# HISTORIC AND DESIGN REVIEW COMMISSION

**HDRC CASE NO:** 2020-448  
**ADDRESS:** 415 HAYS ST  
**LEGAL DESCRIPTION:** NCB 528 BLK 1 LOT 12  
**ZONING:** IDZ-1, H  
**CITY COUNCIL DIST.:** 2  
**DISTRICT:** Dignowity Hill Historic District  
**APPLICANT:** Juan Fernandez/CVF LLC  
**OWNER:** CVF LLC  
**TYPE OF WORK:** Construction of three, 2-story residential structures  
**APPLICATION RECEIVED:** December 18, 2020  
**60-DAY REVIEW:** Not applicable due to City Council Emergency Orders  
**CASE MANAGER:** Edward Hall

The applicant is requesting a Certificate of Appropriateness for approval to construct three, 2-story, single-family residential structures on the vacant lot at 415 Hays, located within the Dignowity Hill Historic District.

### Section Details: Operator

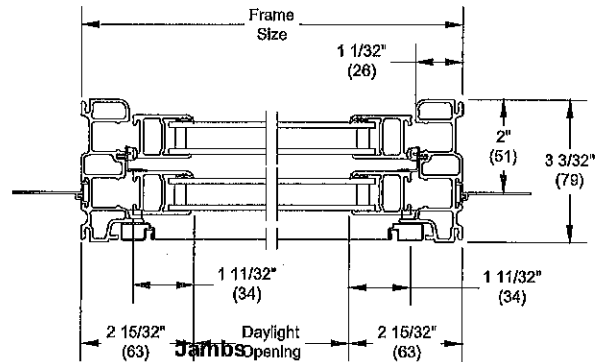
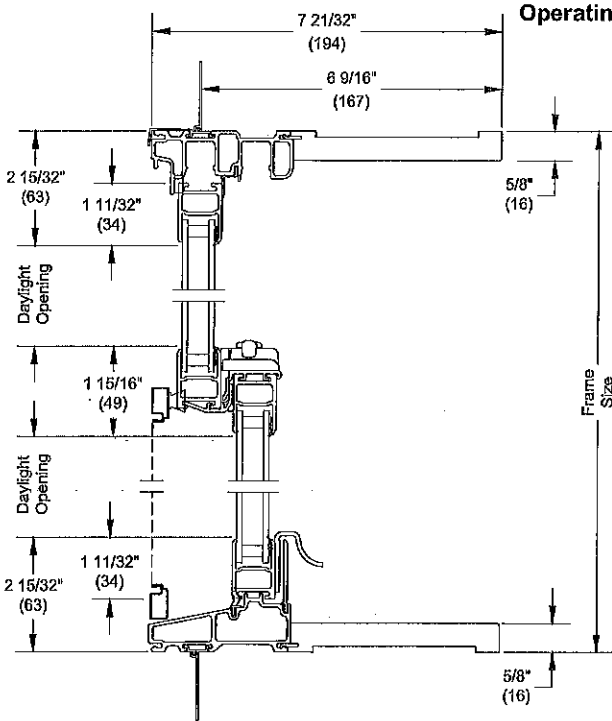
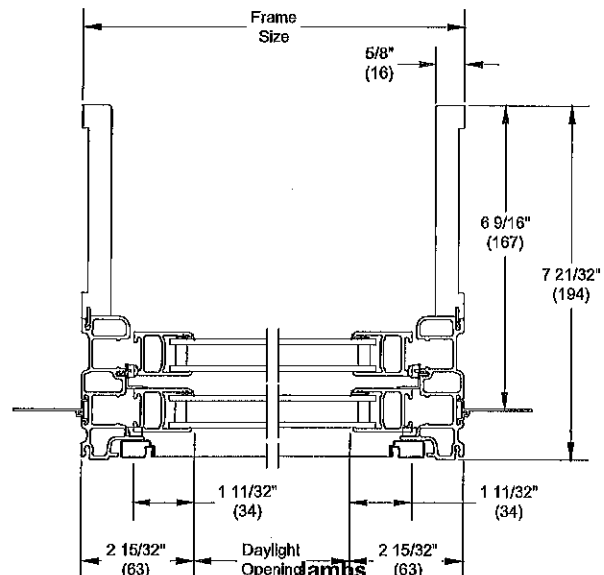
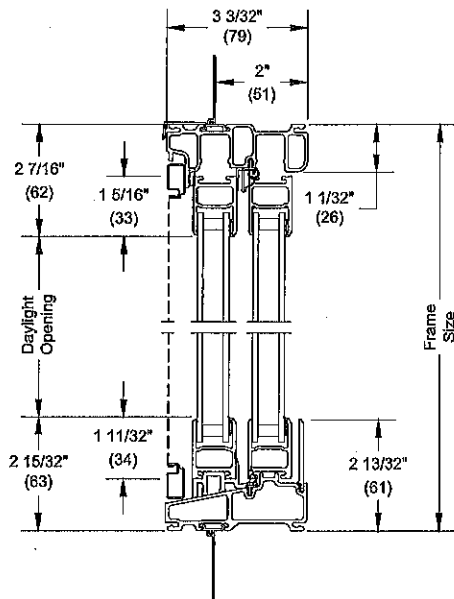
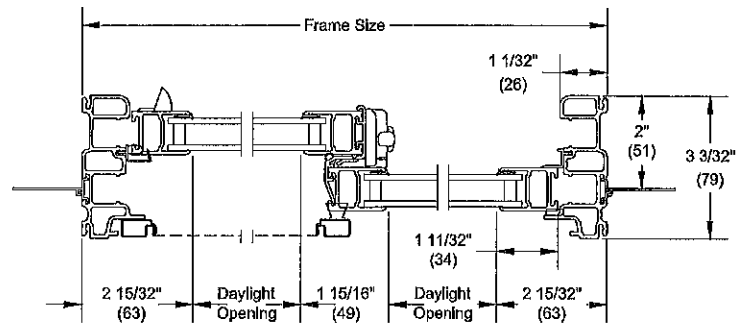
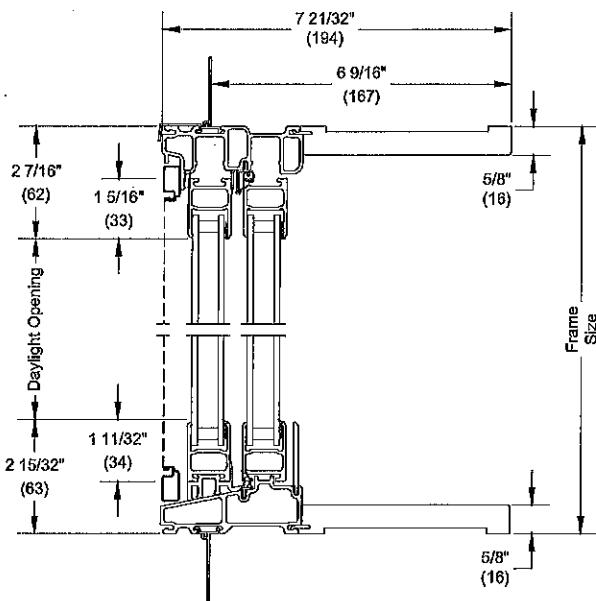
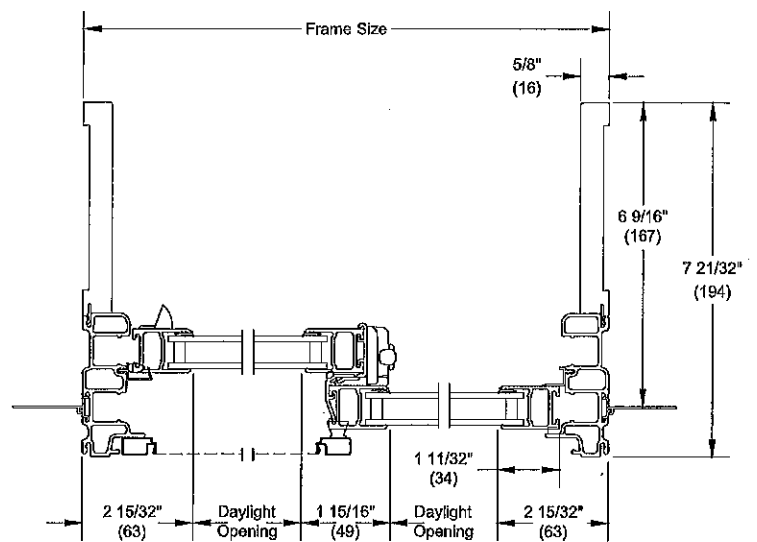
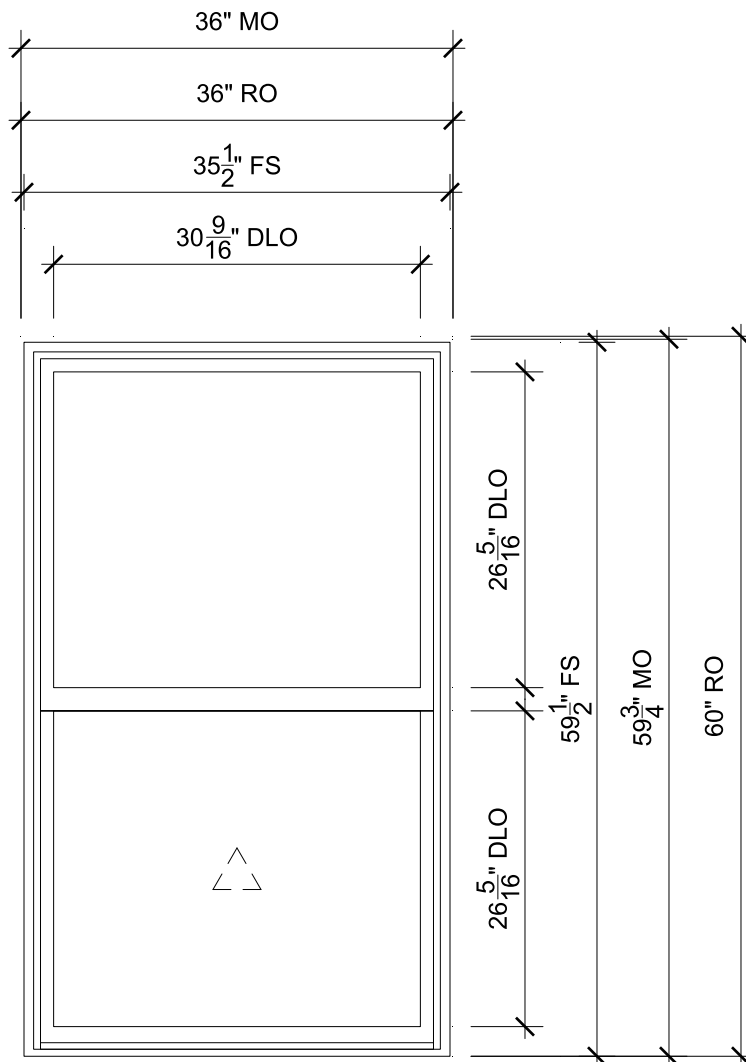
- m. WINDOW MATERIALS – The applicant has proposed fiberglass windows. Staff finds that wood or aluminum clad wood windows that meet staff's standard specifications for windows in new construction should be installed.

SC: Questions regarding window materials (JF: Proposing Marvin Fiberglass windows).

- iii. That wood or aluminum clad wood windows that are consistent with staff's standards for windows in new construction be installed, as noted in finding m and in the applicable citations.
